Joint Planning Commission and City Council Form-Based Code Committee

Staff notes and Recommendations – 5/18/17 meeting

Parking setback 40-ft at the frontage:

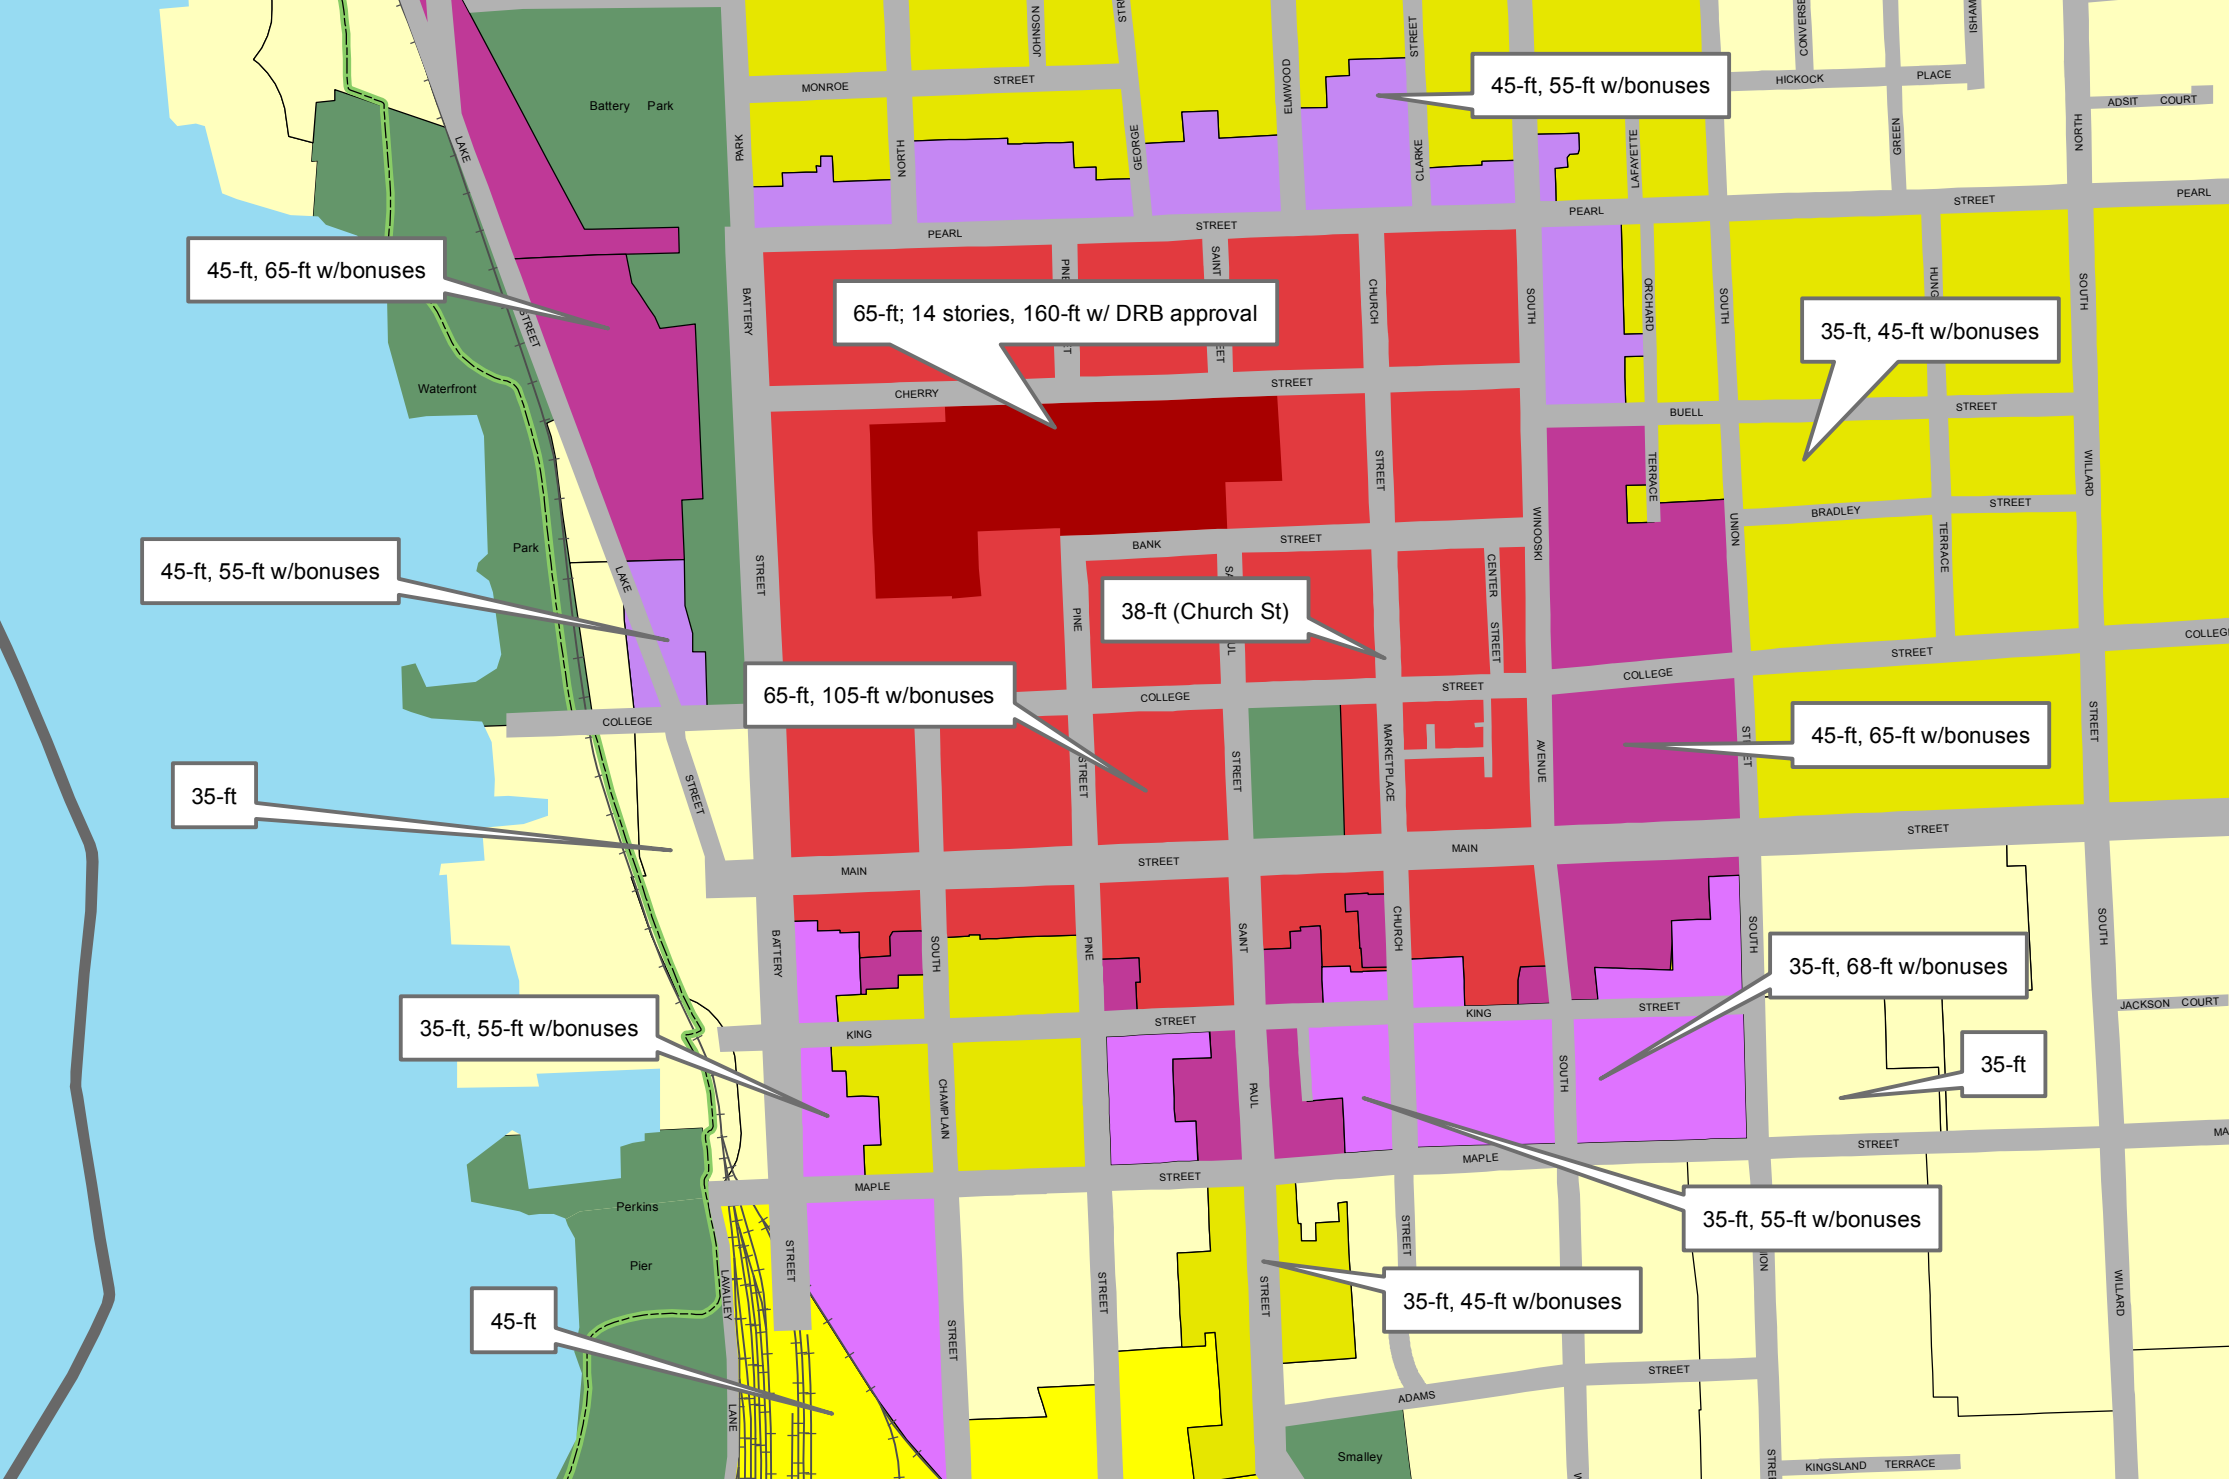
- Reflects Council action taken as part of DMUC Overlay, and expanded across the entire façade rather than just first 1-2 stories.
- Original staff recommendation was 20-ft which is consistent with similar provisions in other ordinances
- Typical double loaded parking level would be 60-ft so this would require a lot a minimum of 100-ft deep in order to accommodate above-ground on-site parking in most cases
- Staff recommendation: Parking should only be setback 20-ft from the frontage.

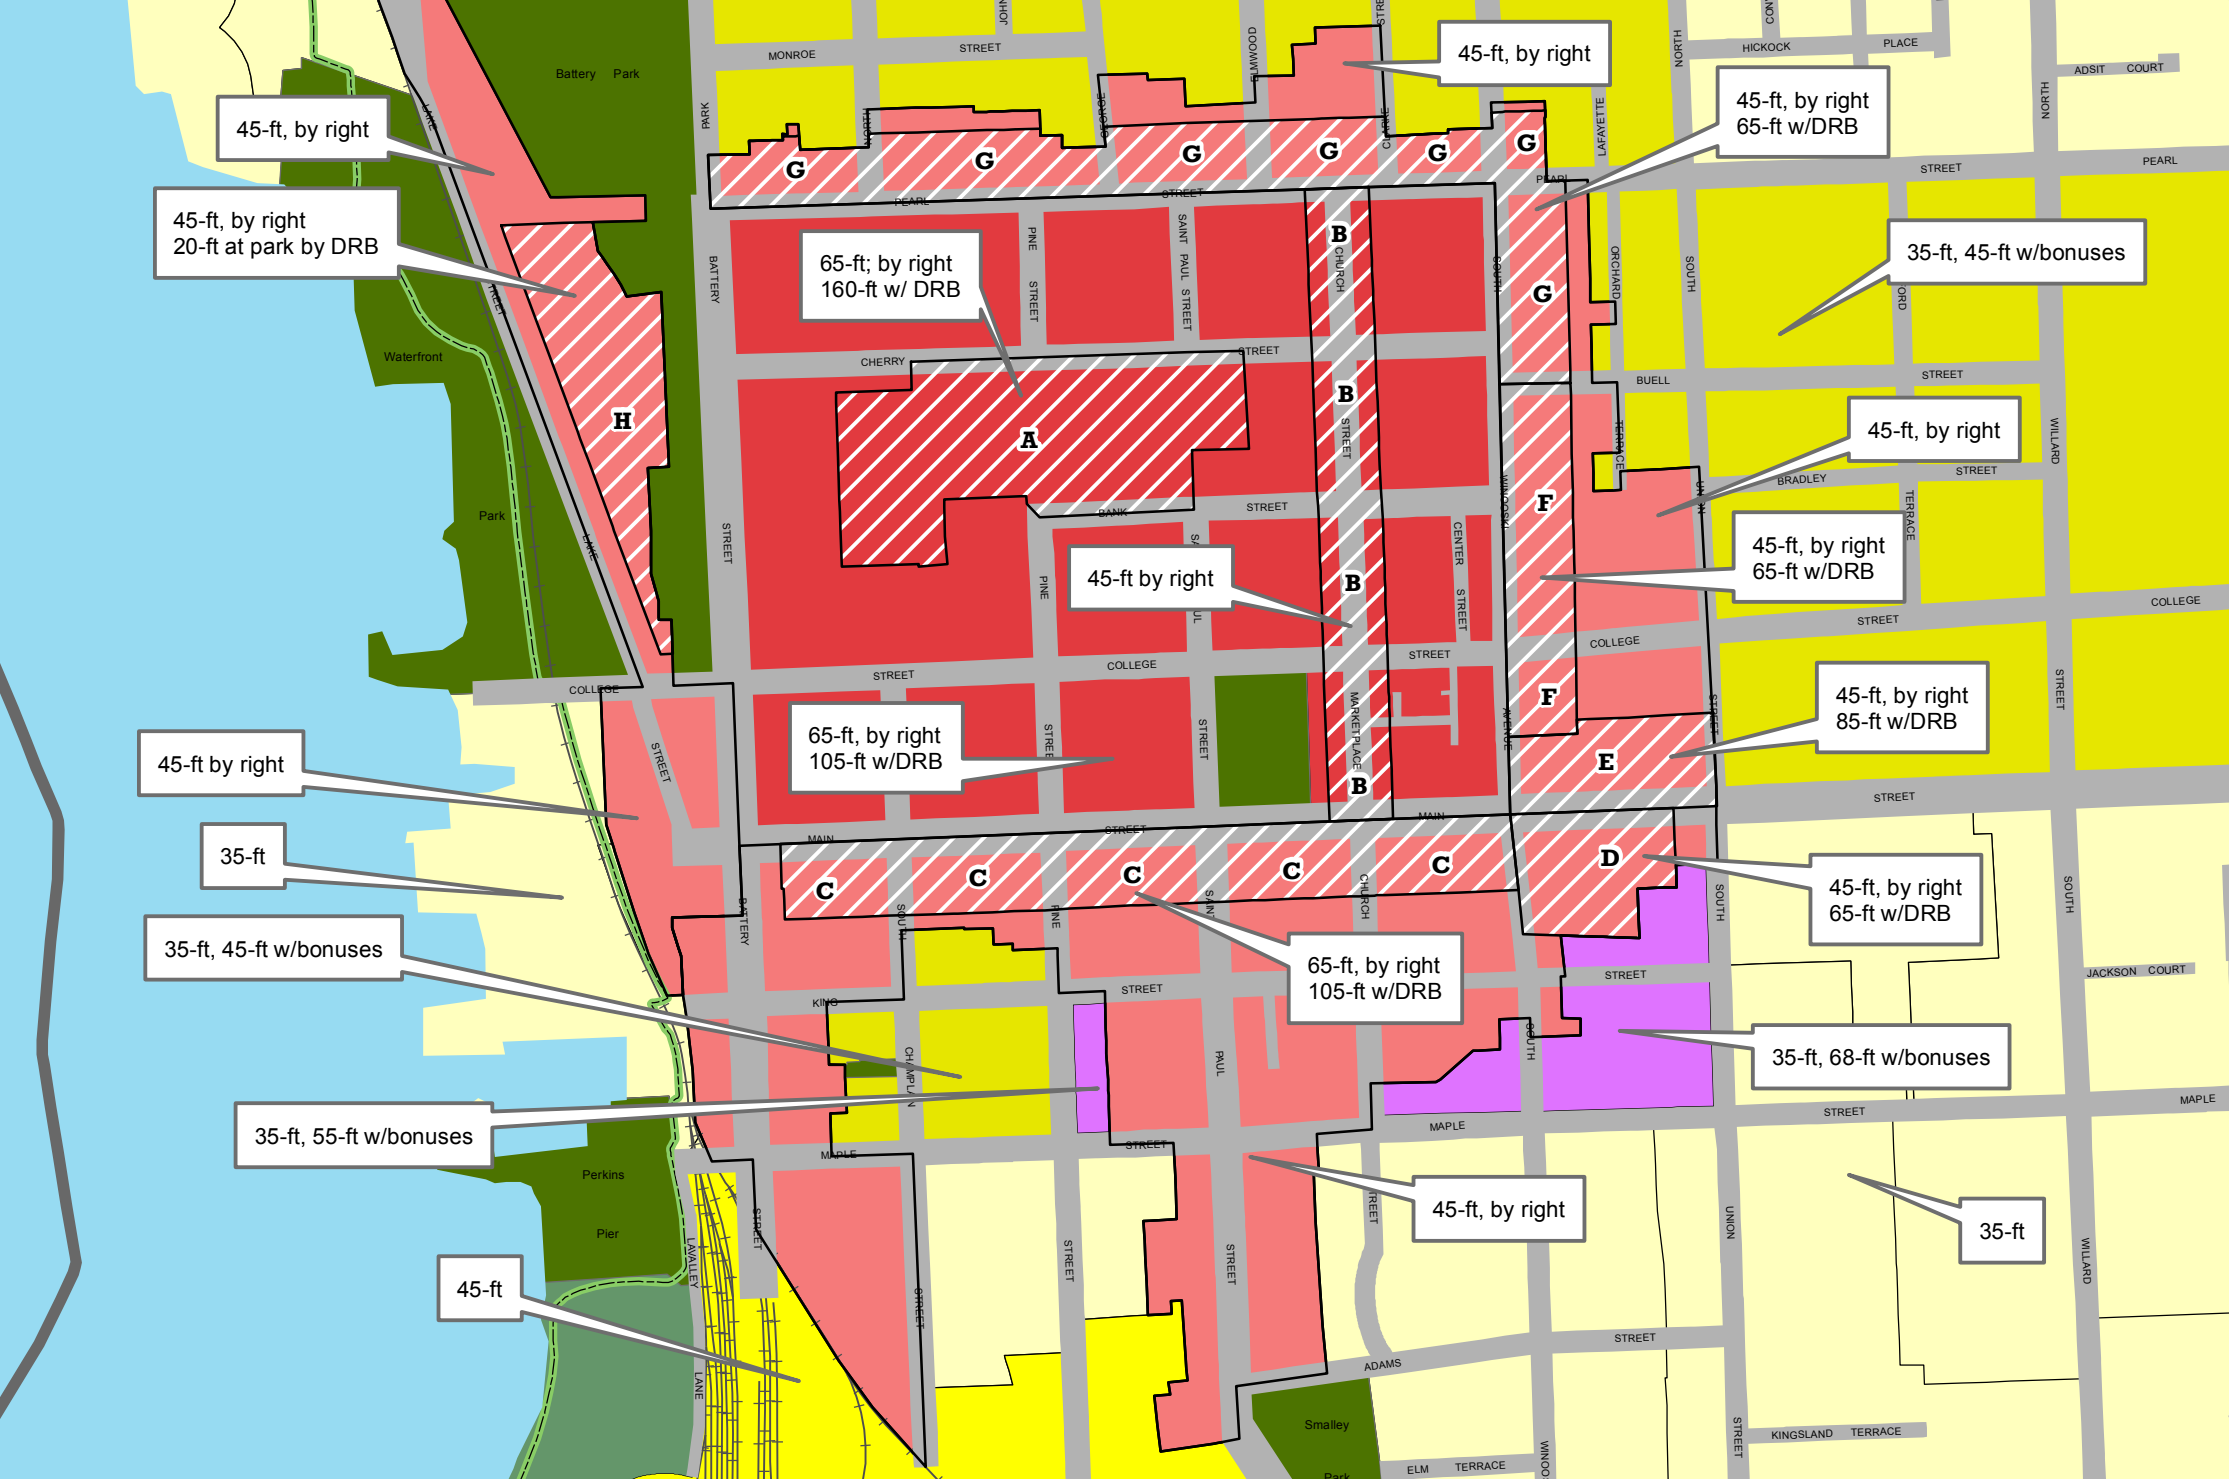
- Most recent analysis of the proposed maximum height limits in the FBC identified a number of inconsistencies with current and adjacent height limits
- Staff recommendation: see attached.
